Access Compliance Report

Public Rights-of-Way

Intersection ID: 46749	Main Street: NORMANS_LANDING_DR	Cross Street: HAVASU_ST	Location: SW
ADA ID: 9E028F8F790F	Ramp Type: PerpDiag	Initial Pass/Fail: Fail	Overall Compliance: No
Severity Score: 22.5			
Codes/Mitigation Info/Possible Solution		Field Measurements/Component Compliance

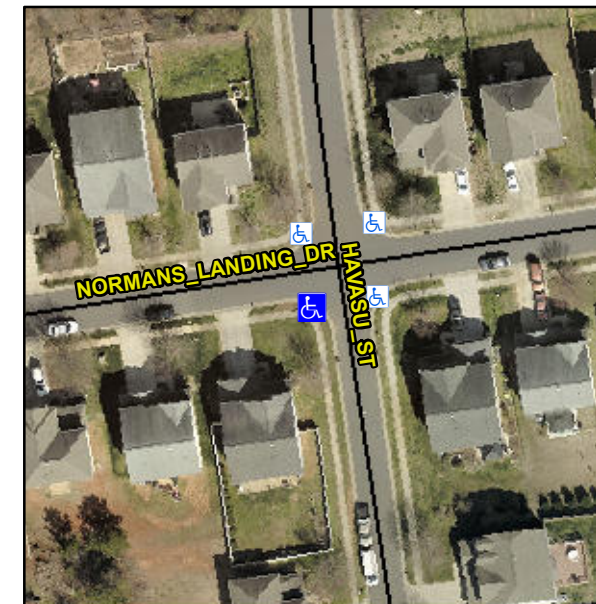
Not Found, R304.5.1, R304.2.2, R304.5.3

Compliance	Description	Data	Compliance	Description	Data
N/A	Ramp Length (in)	48.0	No	Ramp Slope (%)	8.8
No	Ramp Width (in)	45.5	No	Ramp XSlope (%)	3.5
N/A	Flare Type LT	N/A	N/A	Flare Type RT	N/A
N/A	Flare Slope LT (%)	N/A	N/A	Flare Slope RT (%)	N/A
N/A	Flare Traversable LT?	N/A	N/A	Flare Traversable RT?	N/A
N/A	Landing Length (in)	N/A	N/A	DWS Provided?	N/A
N/A	Landing Width (in)	N/A	N/A	DWS Contrast?	N/A
N/A	Landing Slope (%)	N/A	N/A	DWS Length (in)	N/A
N/A	Landing X Slope (%)	N/A	N/A	DWS Full Width?	N/A
N/A	Landing Curb? (Y/N)	N/A	N/A	DWS Offset (in)	N/A
N/A	Shared Landing?	N/A			
N/A	Gutter Ponding?	N/A	N/A	Gutter Slope (%)	N/A
N/A	Gutter Lip Ht (in)	N/A	N/A	Gutter X Slope (%)	N/A
N/A	Painted X Walk1?	No	N/A	Painted X Walk2?	No
	X Walk 1 Direction	To E		X Walk 2 Direction	To N
N/A	X Walk 1 Width (in)	N/A	N/A	X Walk 2 Width (in)	N/A
	X Walk 1 Slope (%)	3.0		X Walk 2 Slope (%)	2.5
	X Walk 1 X Slope (%)	1.2		X Walk 2 X Slope (%)	5.4

Remove & Replace Curb Ramp With Two New Directional Ramps or Equivalent.
